**DEFENSE NUCLEAR FACILITIES
SAFETY BOARD**

Staff Issue Report

SUBJECT: Plugging of Process Lines, Pretreatment Facility, Waste Treatment and Immobilization Plant, Hanford Site

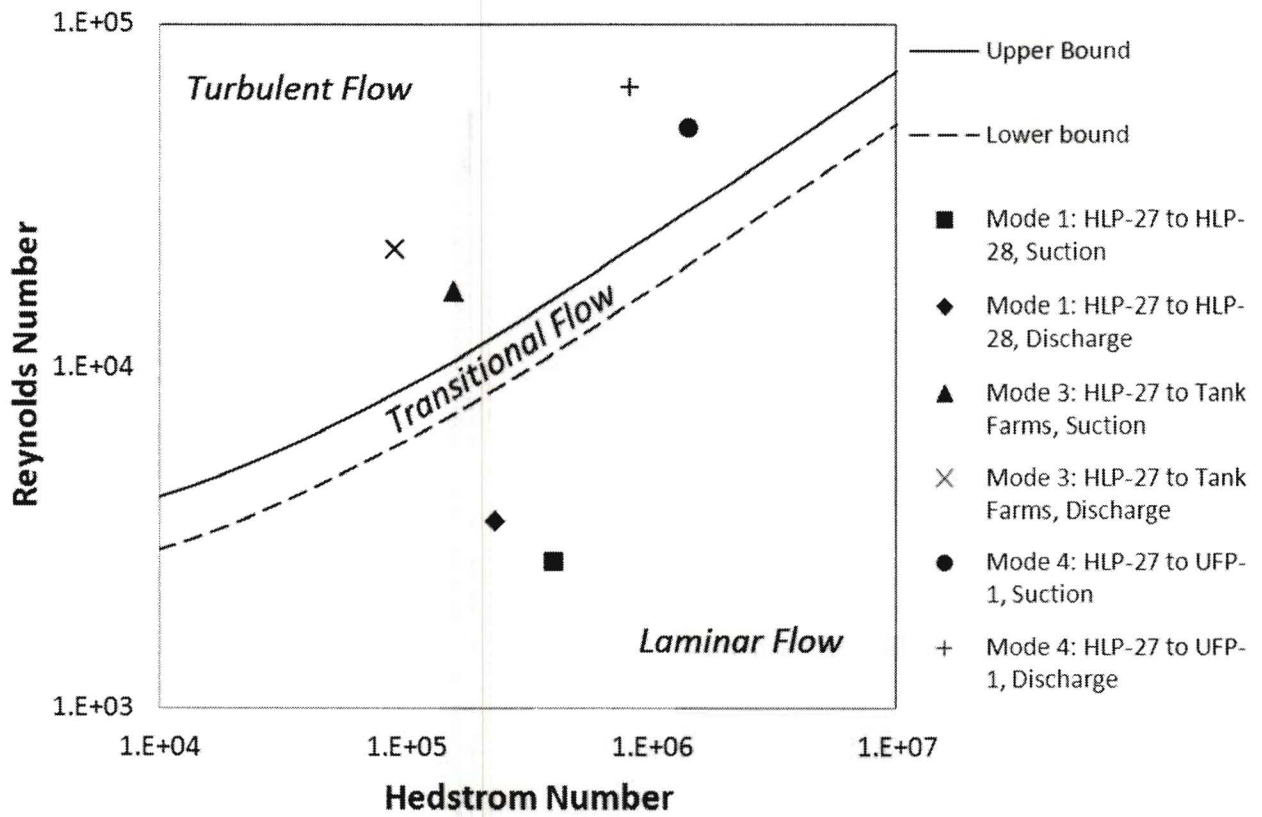
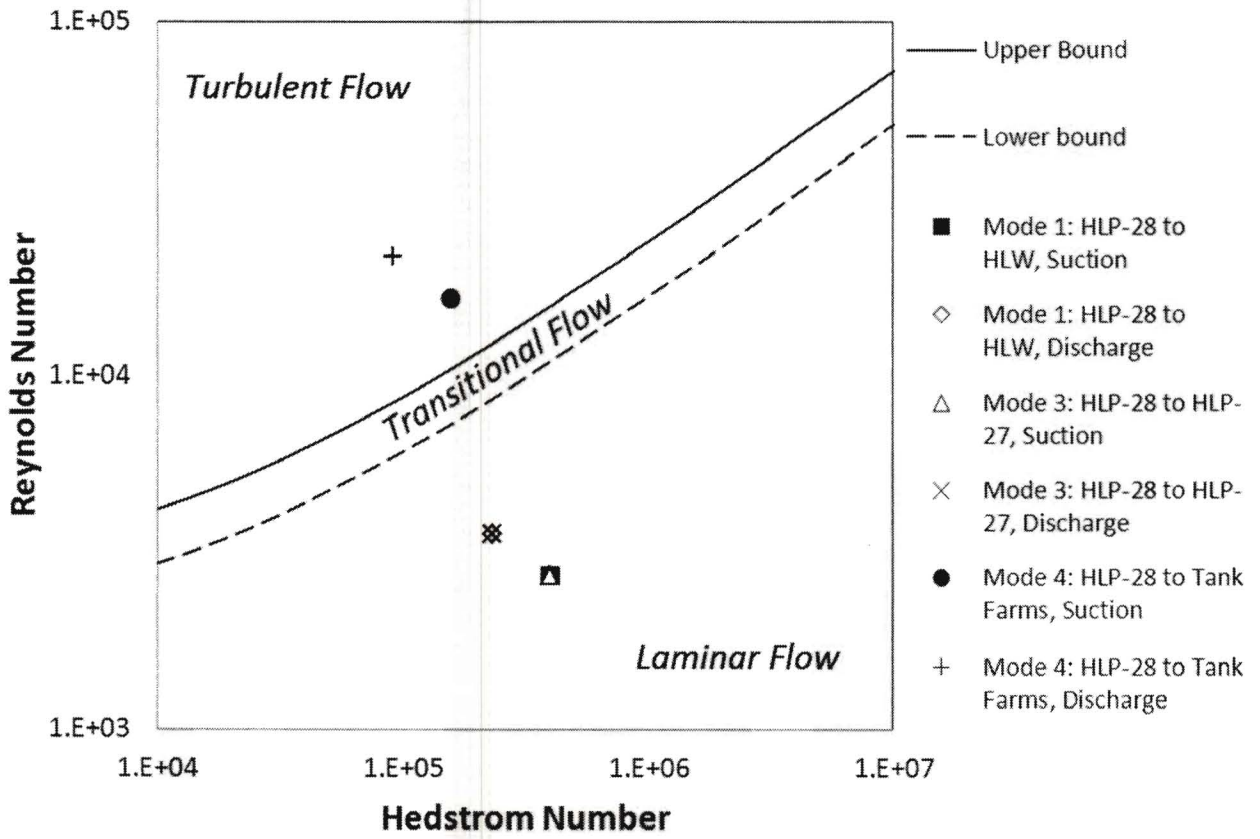
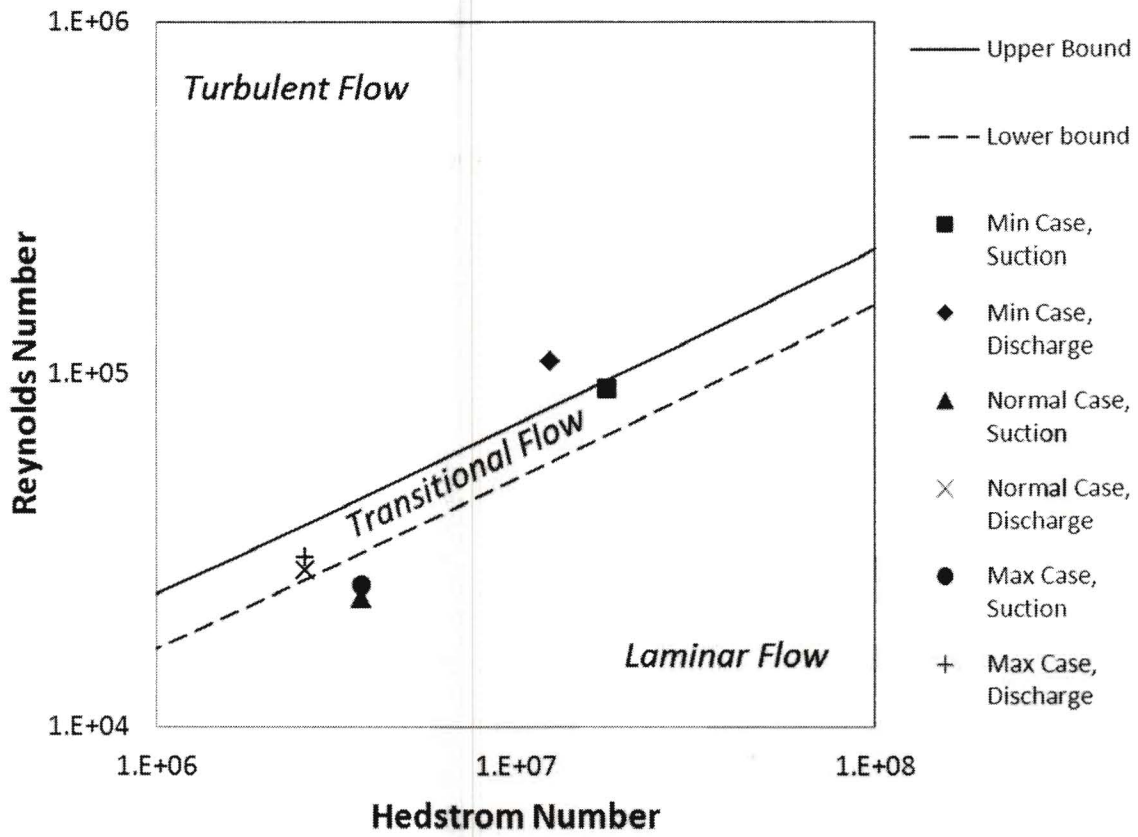
Figures A-1 through A-3 below depict flow regimes for centrifugal pumps at the Pretreatment Facility (PTF) for transferring non-Newtonian slurries (Prado, 2011a, 2011b; Bauer, 2011). These figures show that the current design strategy for non-Newtonian pipelines at PTF will produce laminar or transitional flow in several non-Newtonian process lines, which may lead to pipeline plugging.

Figure B-1. SAR Number for Simulated WTP Process Streams

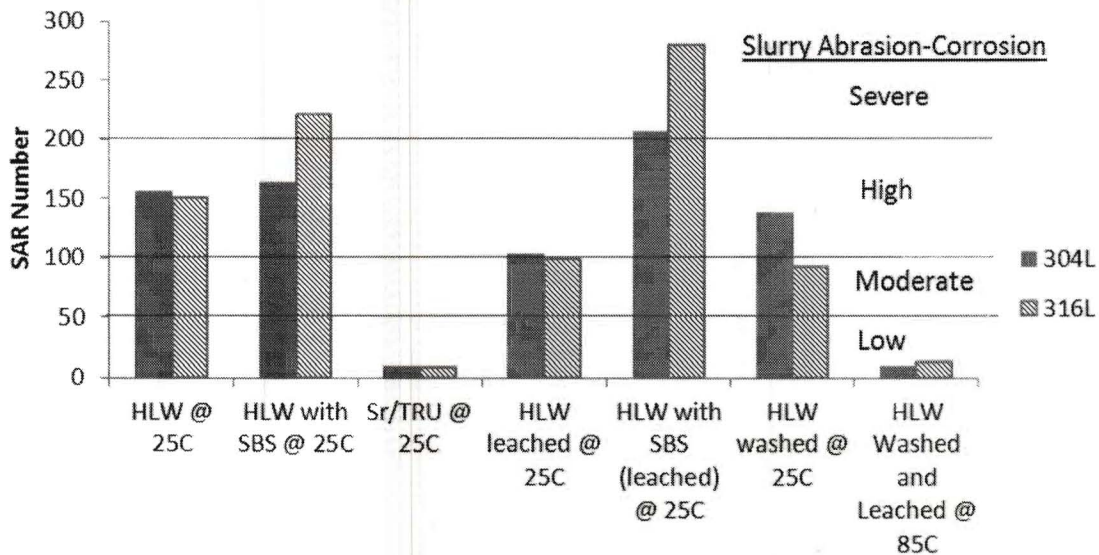
Duignan (2002) produced seven WTP waste stream simulants and performed a standard abrasivity test per ASTM G75-01, *Standard Test Method for Determination of Slurry Abrasivity (Miller Number) and Slurry Abrasion Response of Materials (SAR Number)* (American Society for Testing and Materials, 2001), to determine a Slurry Abrasion Response (SAR) number for two types of stainless steel used by the WTP project, 304L and 316L. The ASTM G75 method uses a Miller number machine to determine the severity of abrasion-corrosion of the slurry on the wear materials by measuring the rate of mass loss from the material specimen and converting these data to a SAR number. During a test, a stainless steel wear block is attached to a reciprocating arm that slides the block at a controlled rate across a trough filled with slurry. Mass loss of the wear block occurs as the bottom of the block abrades from the sliding action of the block, slurry, and bottom of the trough. The ASTM method specifies that the bottom of the trough is made of a standard lap material, neoprene. The block is machined to dimensions specified by the standard and loaded with a total downward force of 22.24 N (5 lb). SAR number results from the seven simulated WTP slurries are shown in Figure B-1 along with a rating scale that shows regions of low to severe abrasion-corrosion. The results indicate that process chemistry, e.g., the addition of the submerged bed scrubber (SBS) solution, plays an important role in abrasion-corrosion of WTP process streams.

BNI's wear calculations assume that the stainless steel piping will experience little erosion at low flow velocities due to the small size and amount of hard waste particles. ASTM G75-07 (American Society for Testing and Materials, 2007) states:

For sliding beds that are expected to occur in the WTP piping, abrasion-corrosion depends on the frictional force between the sliding bed and the pipe invert that is impacted by several key parameters such as the height of the sliding bed, particle and liquid densities, void fraction, and centrifugal forces from the bed moving through pipe elbows. BNI has not analyzed the specific conditions for abrasion-corrosion in WTP piping due to sliding beds of particles. The Board’s staff found a large number of publications in the technical literature on the topic of wear rates in piping with sliding beds (e.g., Miller and Schmidt, 1984; Pagalthivarthi et al., 2009; Roco and Addie, 1987).
